Access Compliance Report

Public Rights-of-Way

(Curb Ramps)

Intersection ID: 42727	Main Street: SPEEDWELL_CT	Cross Street: PICKEREL_LN	Location: W
ADA ID: 1A8B0EC71B06	Ramp Type: PerpDiag	Initial Pass/Fail: Fail	Overall Compliance: No
Severity Score: 8.75			
Codes/Mitigation Info/Possible Solution		Field Measurements/Component Compliance

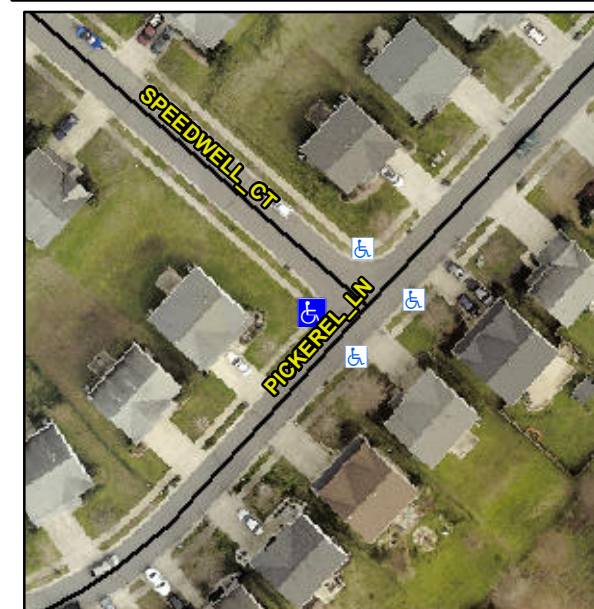
Not Found, R304.5.1

Remove & Replace Curb Ramp With Two New Directional Ramps or Equivalent.
